QUERIES ANSWERED BY ARM JOINT COMMITTEE

16th March 2021

Topic: Multiple pipes in trenches at crossings

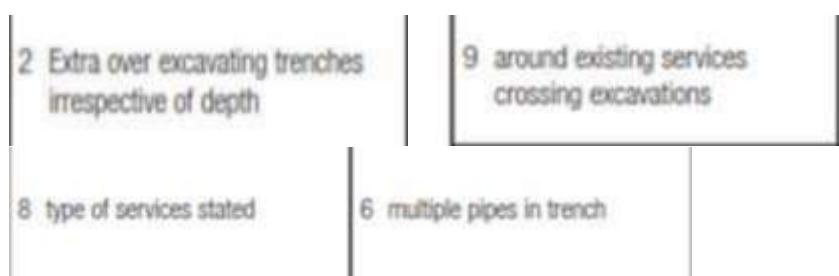
Can the Committee advise on the interpretation of the Rules shown below:

Our understanding of this is that the '*multiple pipes in trench*' that are referred to means the pipes that are in the new trench (i.e., if an ESB line has 2 nr ducts then this is 2 nr crossings).

Is our understanding correct?
